SPARS NEW YORK REGIONAL MEETING

REVIEW : "PROBLEMS AND SOLUTIONS / AMPEX 1200"
SPEAKER: MICHAEL GUTHRIE, DIRECTOR OF ENGINEERING
RECORD PLANT STUDIOS, LTD. -NYC

Record Plant Studios MM-1200 modification procedures:

CHANGES AND ADDITIONS TO TAKEUP TENSION CONTROLLER KIT * Record Plant Studios
2/16/81

13) MDA mods.

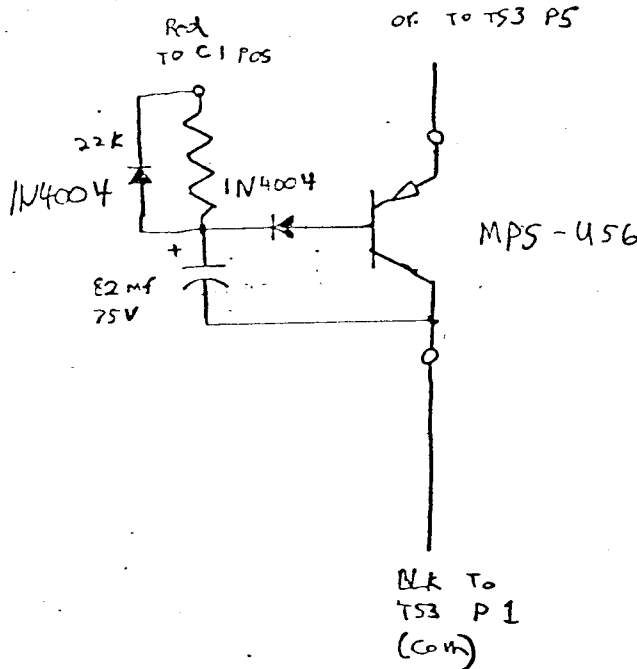
- 1) install SET 31307 transistors in Q101,102,105,106. Add the 220 ohm resistors, and the diodes as shown in the tension kit instructions. Note the 013-678 can be replaced with a 1n4004 etc. if you're not an Ampex dealer.

- 2) add two fuse holders to the PWA panel as shown. cut the lands leading to the Q1,7 collectors between C2,9 and the transistors. Drill two holes to pick up these lands on each side and wire to the fuse holders. install 1/4 or 3/8 A sol blow fuses in the fuse holders. These fuses will, at least in most cases, protect Q1,7 from failure when the transistors on the heatsink assembly fail.

- 3) if installing a tension kit, follow the instructions concerning further mods that go with that kit. Do not do these unless you are installing the kit.

- 4) Make two duct plates as shown in the drawing. these should be black anodise aluminium if possible or painted flat black if not. Drill and tap four holes for 6-32 screws in each heat sink, and use 6-32 X 1 1/4" screws, lock washers, and flat washers to attach the duct plates to the heat sinks.

- 5) Remove the fan, and turn it around when reinstalling it. it will now blow out. Do not install a filter in this location.

Power Supply Modification Procedure

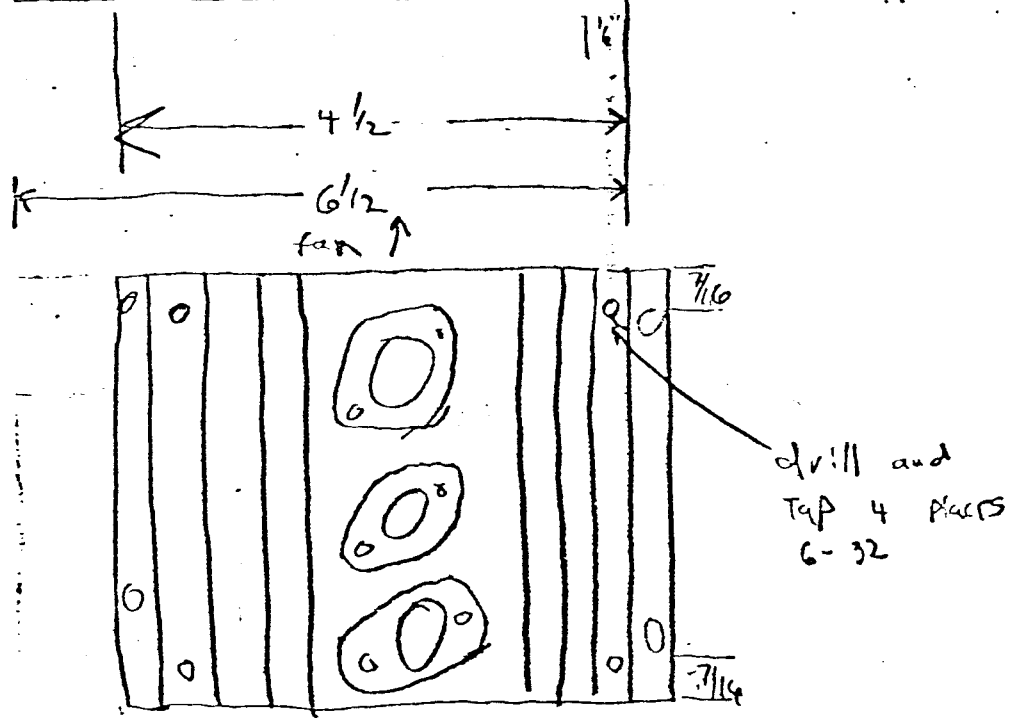
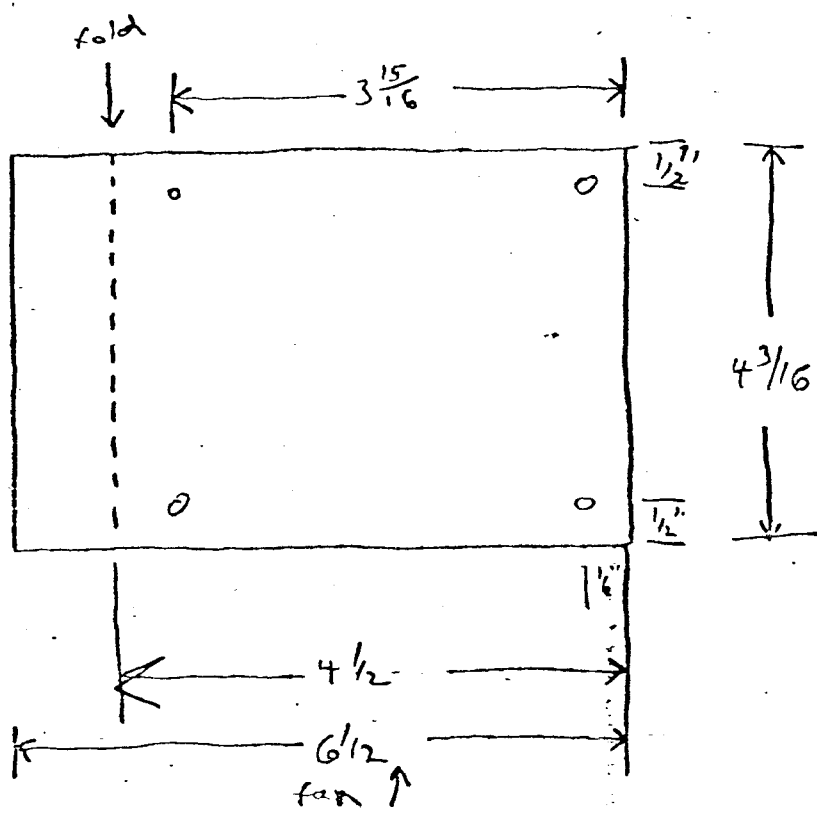
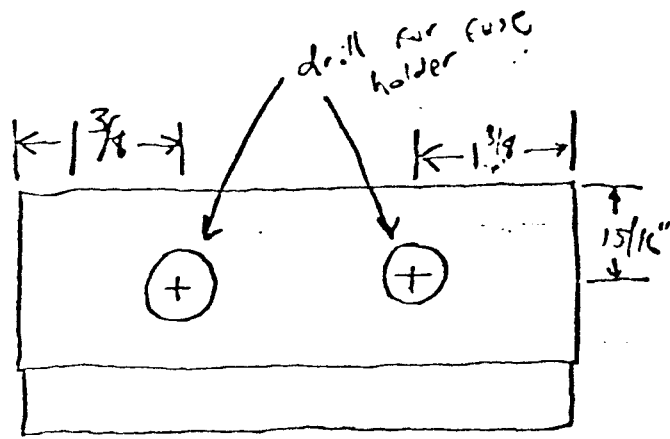
- 1) remove powersupply assembly from machine and remove top and heat sink assembly
- 2) remove jumper connecting C2 neg to chasis
- 3) remove jumper connecting C4 Neg to C5 Neg.

- 4) remove jumper connecting pins 6 and 8 on J1
- 5) remove jumper connection between pin 1 and pins 4,7,10 on J2.
- 6) remove jumper connecting pin 11 and pins 2,5,8 on J2

- 7) add a 16 ga wire from 2,5,8 of J2 to TS2 pin 5 (on heatsink ass), leave existing yellow wire on pin 11 (J2) and existing grey on 2,5,8 (J2).
- 8) add a 16 ga wire from 4,7,10 of J2 to C2 Neg. Leave the existing black wire on pin 1 (J2).

- 9) add a 16 ga wire from C7 Neg (E4) to the heatsink assembly near A4, and connect a 4.7mf 10 v or greater Tant. between A4 input and the added ground wire. the cap can be added to a small terminal strip added a few inches from A4. The input of A4 is the pin that would be the base of a To-3 transistor.

- 10) remove C3 from TS3. near TS3, mount a small turet board with the following on it.

- 11) the MPS-U56 collector connects where C3 neg was. the emitter connects where C3 pos was, and the resistor gets a new wire back to C1 pos.
- 12) solder all ring lugs, both new and existing, and add a lockwasher between the lowest lug and the cap on C1,C2,C4,C5. Neatly tie all new wiring, and reassemble the power supply.
- 13) add an 18 ga wire from Transport Connector J5 (burndy) ^{pin 5} to transport control chassis J1 pin 15.
- 14) reassemble machine, check audio noise with notape, in play, with the head gate closed. reset tensions and power supply voltages if necessary and check for proper operation of all functions.

MM-1200 flutter indicator mod M-6. - 10/11

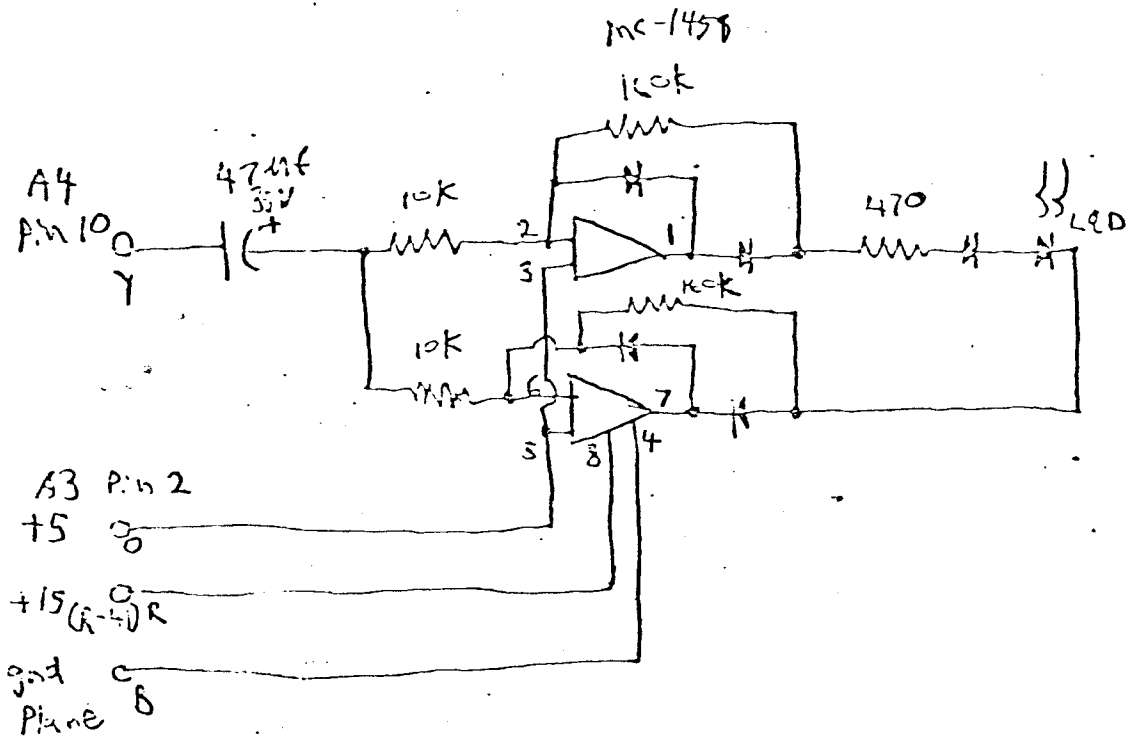
- 14) Here are two unnecessary, but nice additions for the MM-1200. the first is a piggy back board for the capstan servo card, which indicates the presence of bad bearings, servo oscillations, heavy corrections from synchronisers etc which might cause flutter. It is quite sensitive, with a little practice, you can learn to identify flutter below .07%, before it becomes a problem.

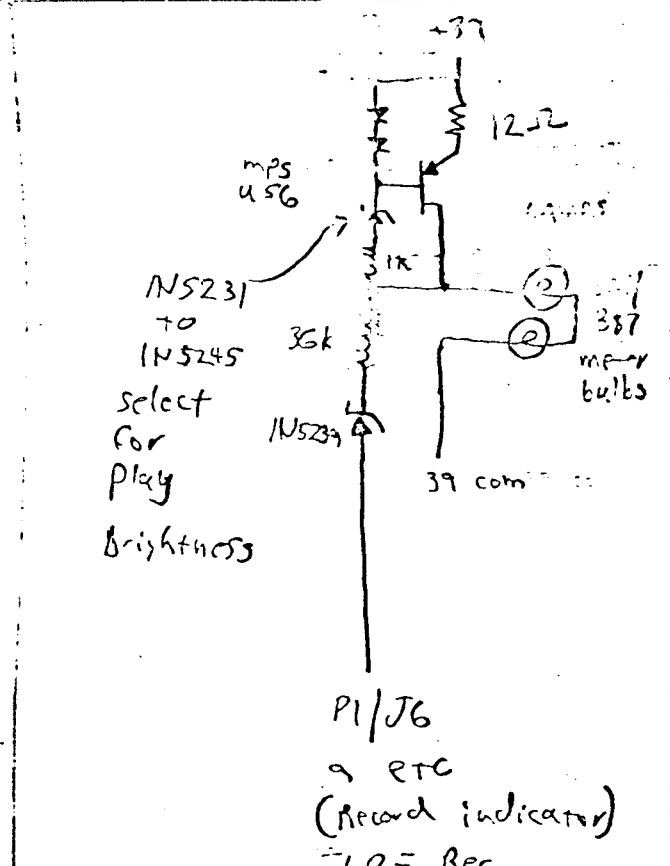
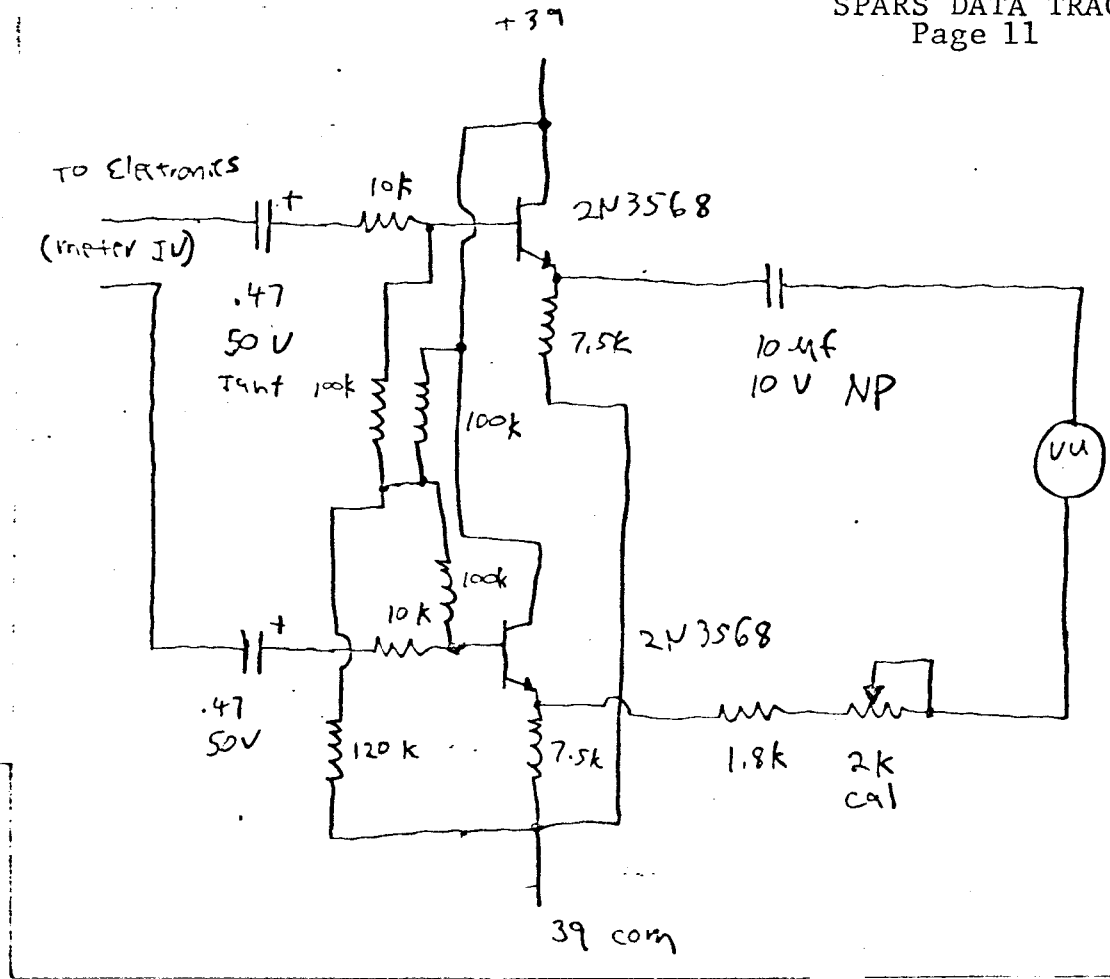
This one is a meter buffer amplifier that will eliminate the distortion caused by the VU meters. This distortion can, under some conditions, be as great as the distortion from the tape. also on this card is a meter lamp buffer that dims the lamps in play, and brightens them in record, giving record indication on the front of the machine. the amplifier does not affect bias metering as an op-amp might, and does not affect the common mode floating of the output transformer.

Page 1A

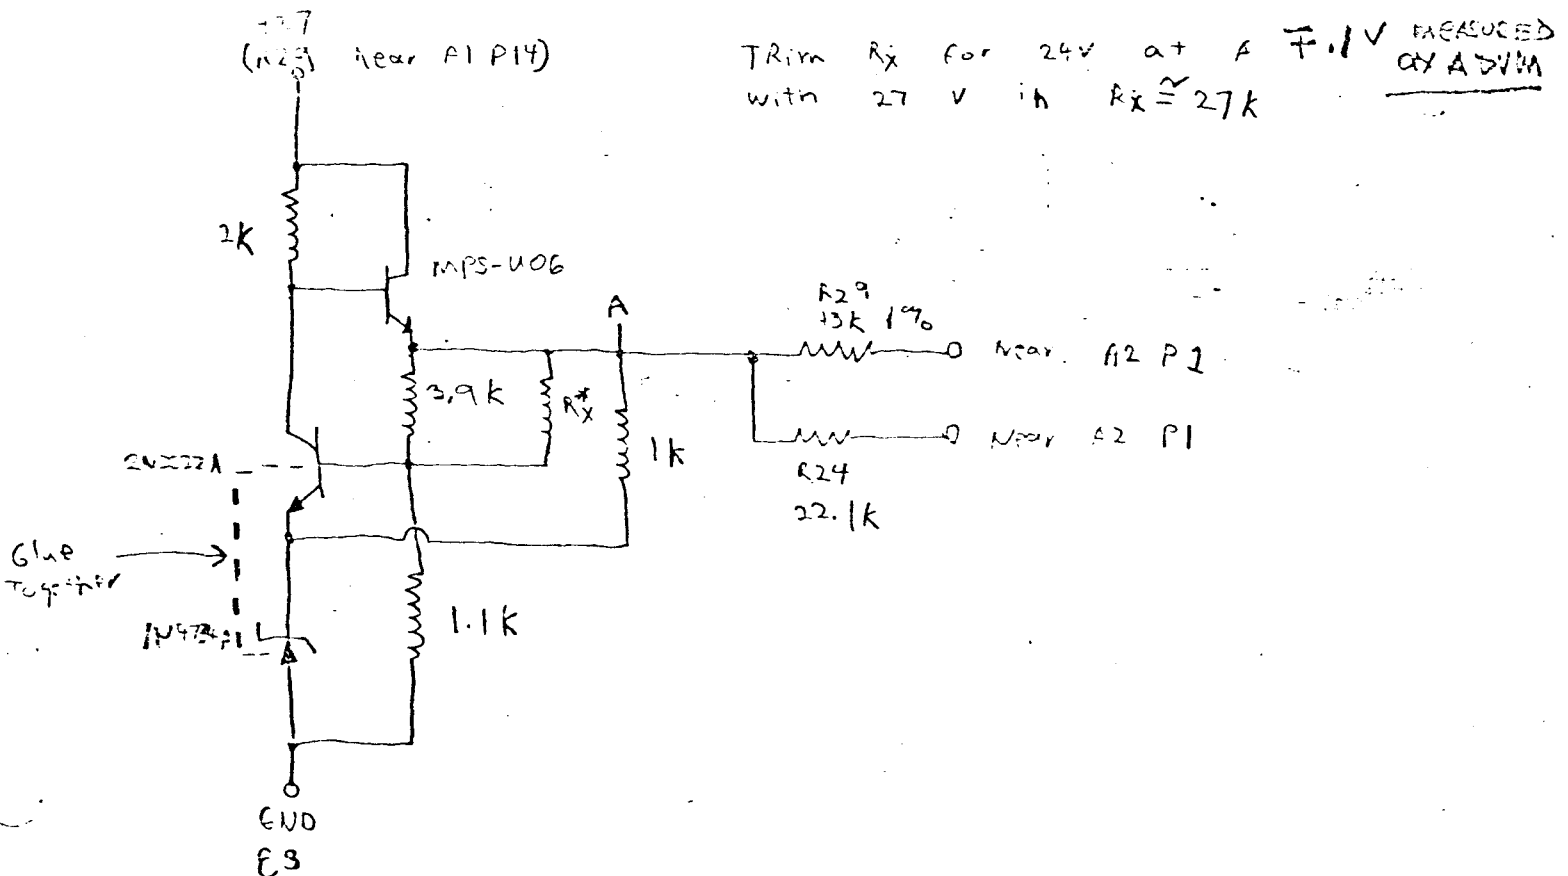
Do not install R 29, but rather install a wire to go to new regulator board. This wire goes in the hole connected to A2 pin 5. (this eyelet is near A2 P1)

Do not install R 24, install a wire here also. the eyelet which connects to A2 P4, near A2 p1

Build the aux 24V regulator shown below, and install on card.

Note changes in takeup MDA, and regulator addition shown below

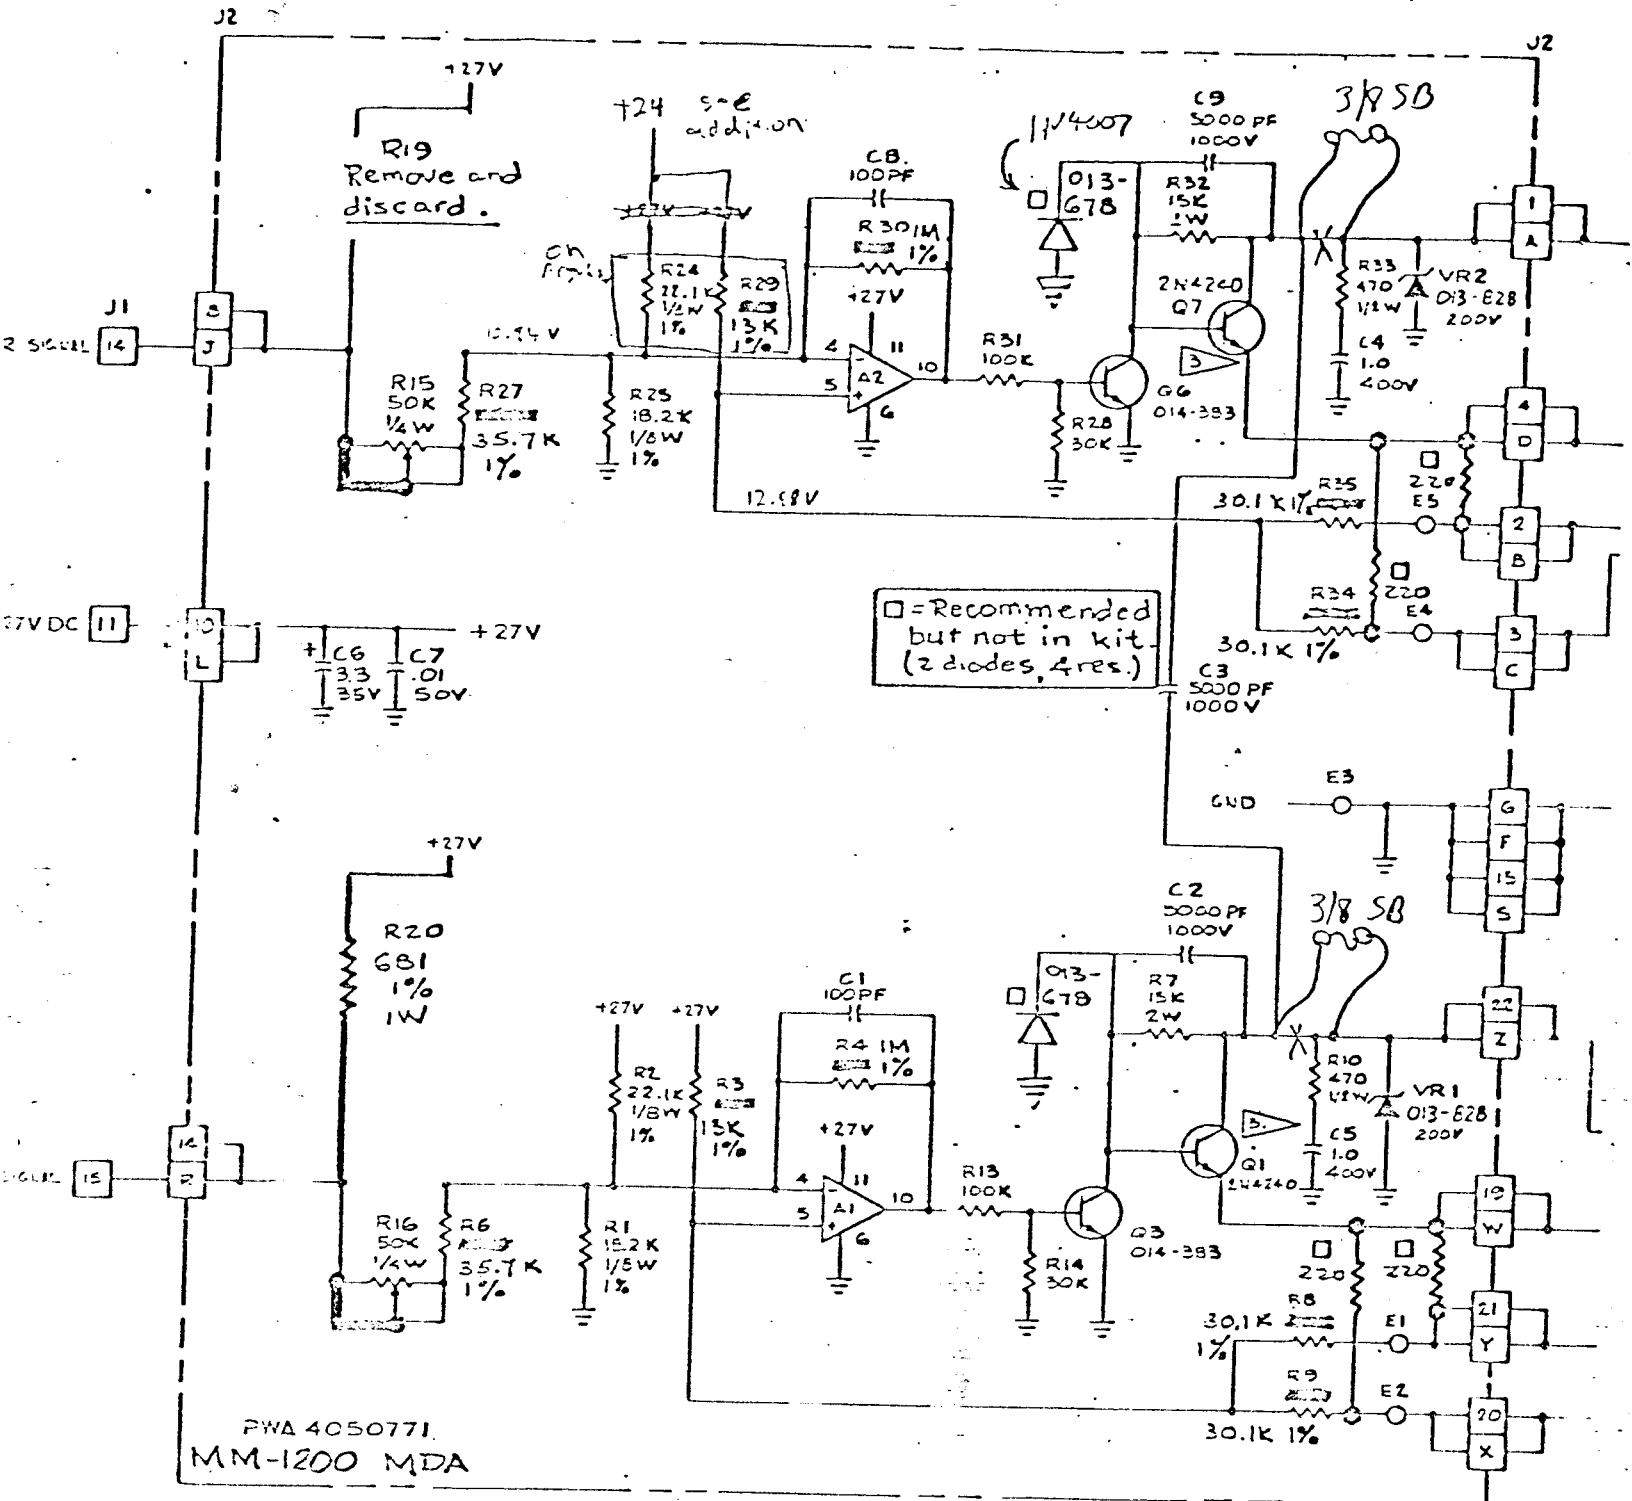
Before completing installation as per page 6, modify the Tension Controller PWA as following; (note changes on schematic, Page 6A)

Add two 1N34 diodes from the bases of Q19, Q20 respectively to the Servo Disable line U10 p13. use tubing on the leads, and place them on the top side of the board

add a 1N5256B zener across c12. the banded end goes to the side connecting to U1 p2. Place this diode on the back side of the board, under C12.
